Planning and Zoning Board Agenda July 9, 2019

- A. Approval of the Minutes of the June 11, 2019 PZB Meeting
- B. Site Plan - Alchem Building Three: A request by Caitlyn Drane, P.E. of eda engineers-surveyors-

- C. Site Plan - Innovation One: A request by Alison Fetner, P.E., of Fetner Engineering, applicant and agent for Shoppes at Progress Center, LLC, property owner, for consideration of a Site Plan to construct a ±30,676 square foot light manufacturing (research and development) facility, with associated paving, grading, drainage, landscaping and infrastructure improvements, on a ±2.80 acre subject property, located southwest of the intersection of US Highway 441 and Progress Boulevard, and north of Research Drive and UF Innovate | Sid Martin Biotech; Tax Parcel Number 03956-010-027 (Quasi-Judicial Hearing).

SUBJECT: Site Plan - Alchem Building Three: A request by Caitlyn Drane, P.E. of eda engineers-surveyors-planners, inc., applicant and agent for James D. Talton of Alchem Laboratories Corporation, property owner, for consideration of a Site Plan to construct a ±12,000 square foot light manufacturing facility, with associated paving, grading, drainage, landscaping and infra

Sheet title:
DIMENSION PLAN

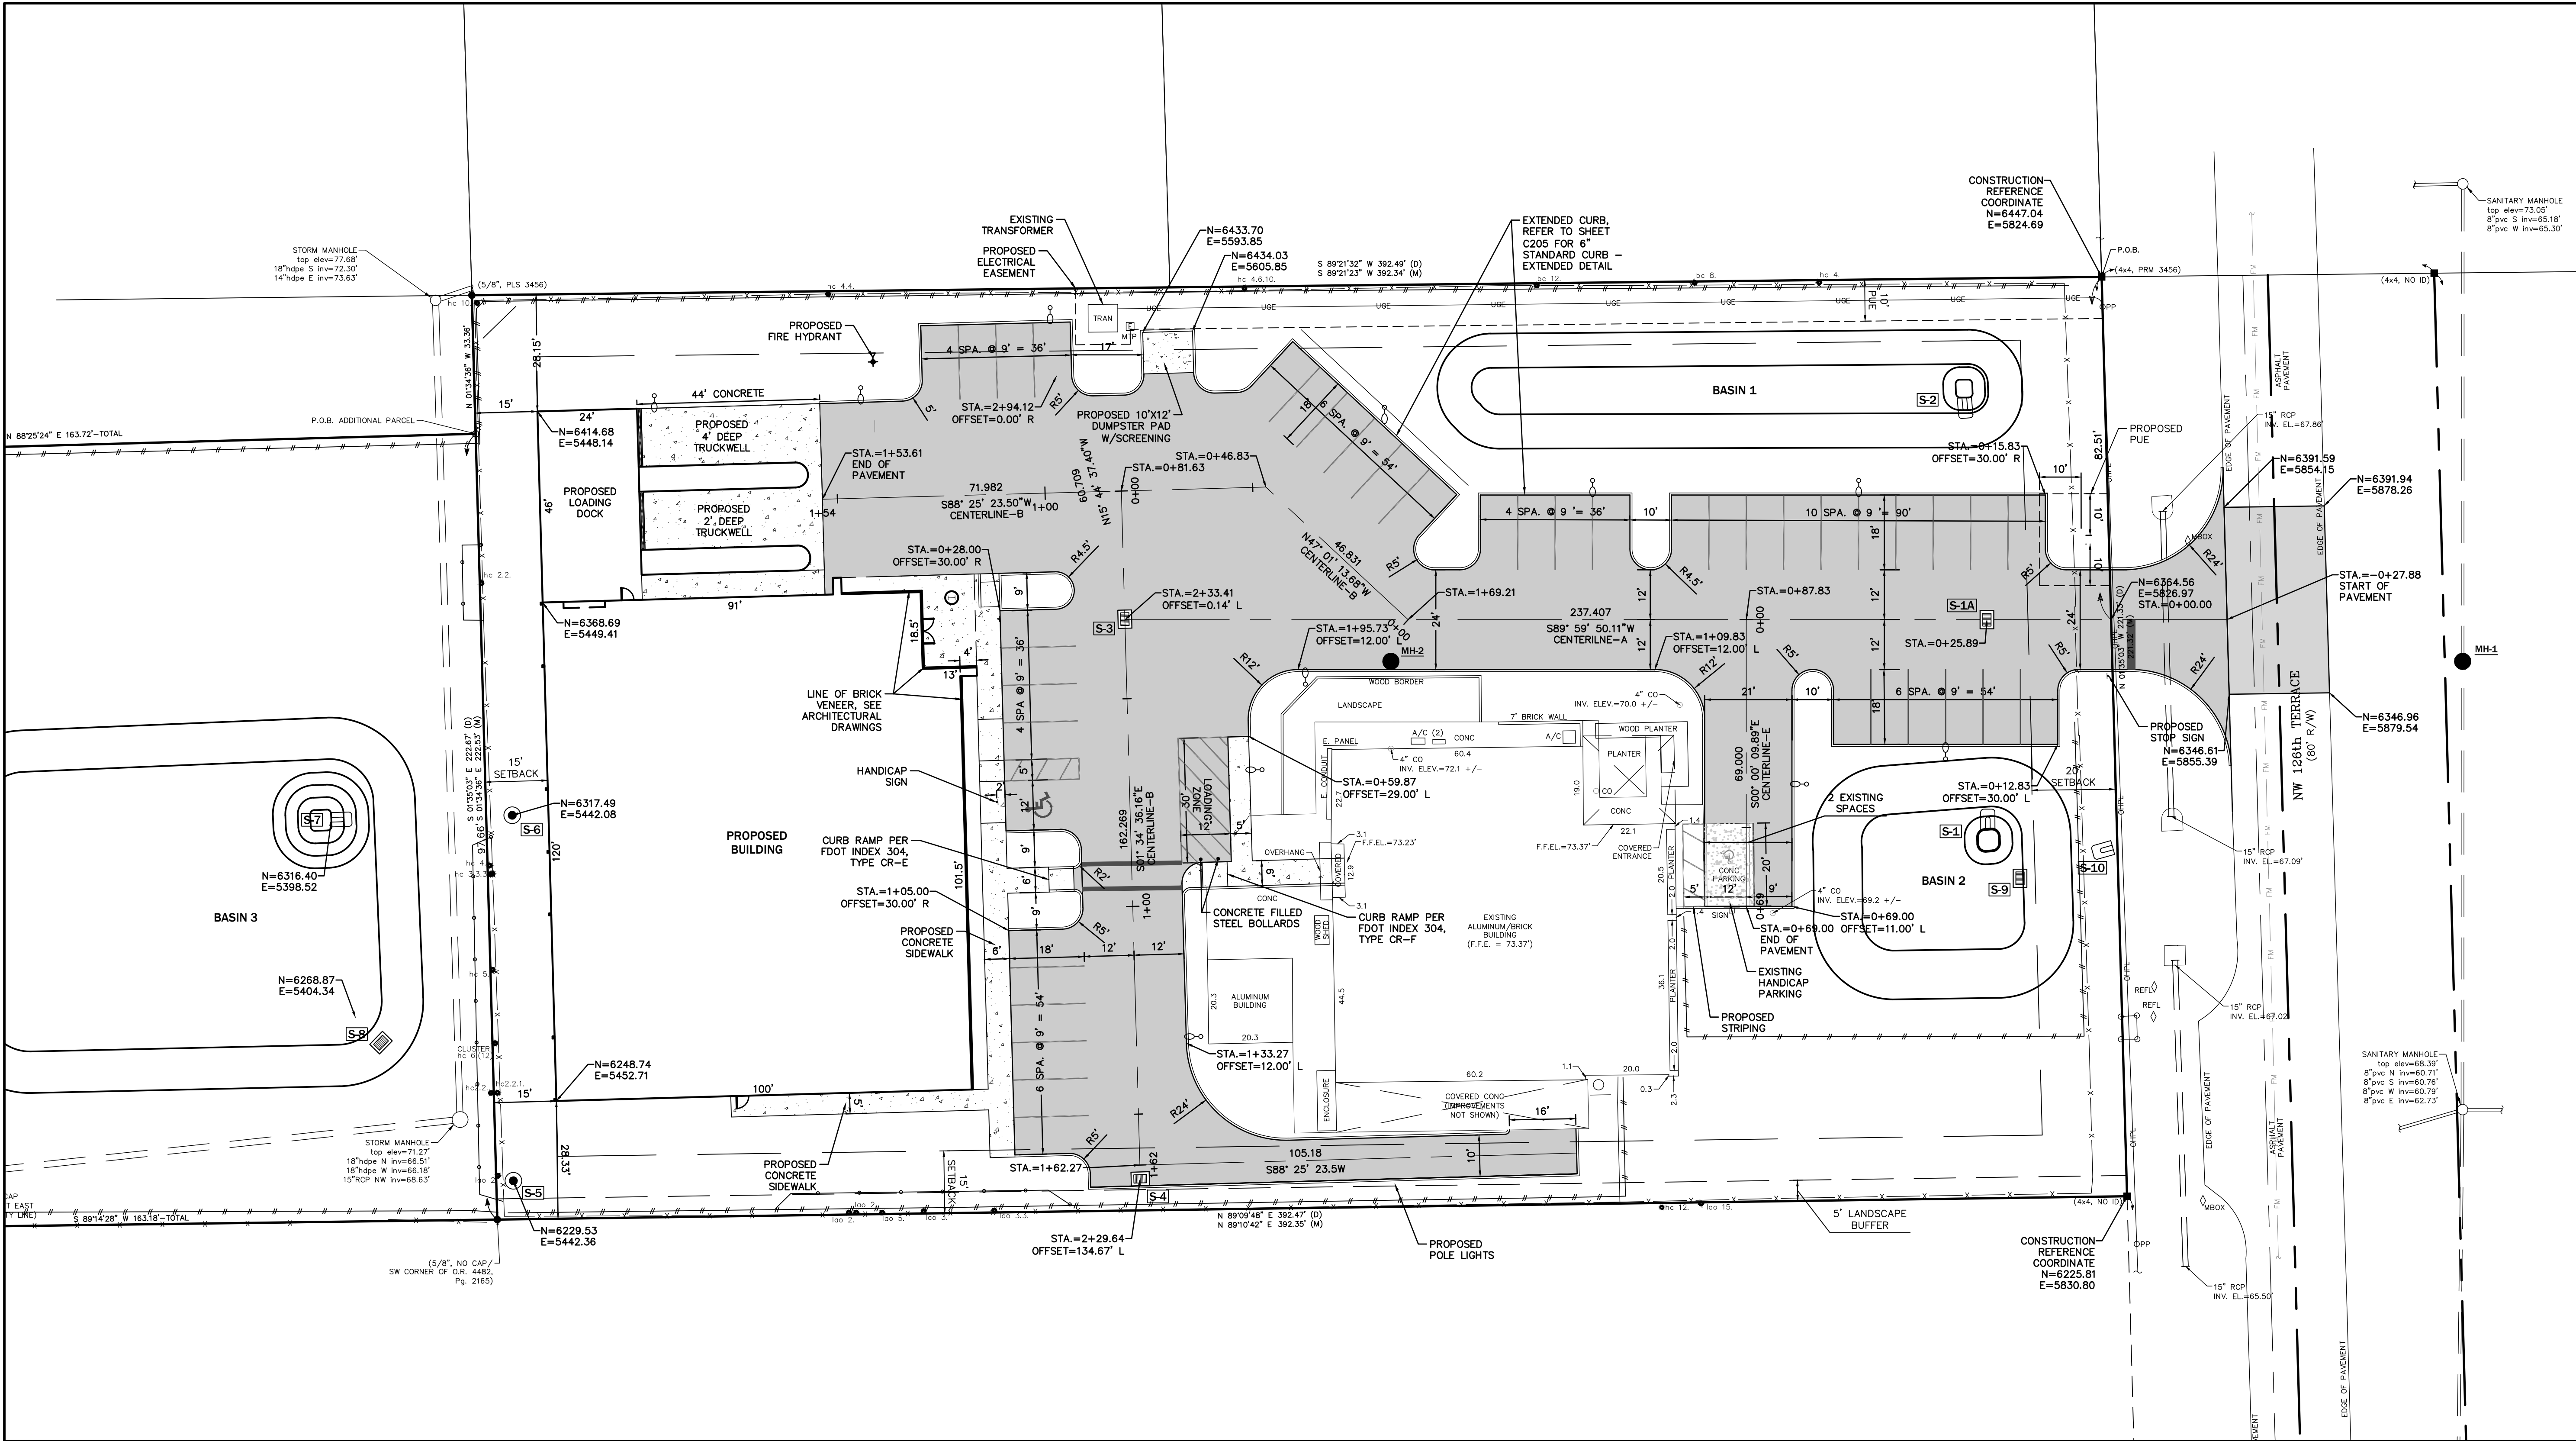
6.	<u>Electrical:</u> Provide easement leading to transformer. [Revise and Resubmit] Comments re: April 25th Submittal DWG C-100: Show the existing UGF; namely, the primary cable from the source to the transformer. In addition to showing the easement around the existing transformer, also show the easement for the existing UGF. Please Revise and Resubmit this DWG. Comments re: June 18th Submittal Approved

6.	<u>Electrical:</u> Provide easement leading to transformer. [Revise and Resubmit] Comments re: April 25th Submittal DWG C-100: Show the existing UGE; namely, the primary cable from the source to the transformer. In addition to showing the easement around the existing transformer, also show the easement for the existing UGE. Please Revise and Resubmit this DWG.

6. Provide easement leading to transformer. DWG C-100: Show the existing UGE; namely, the primary cable from the source to the transformer. In addition to showing the easement around the existing transformer, also show the easement for the existing UGE. Please Revise and Resubmit this DWG.

RESPONSE: The approximate location of the underground primary electric line has been added to the plans with a 10-ft public utilities easement. Refer to Sheet C400.
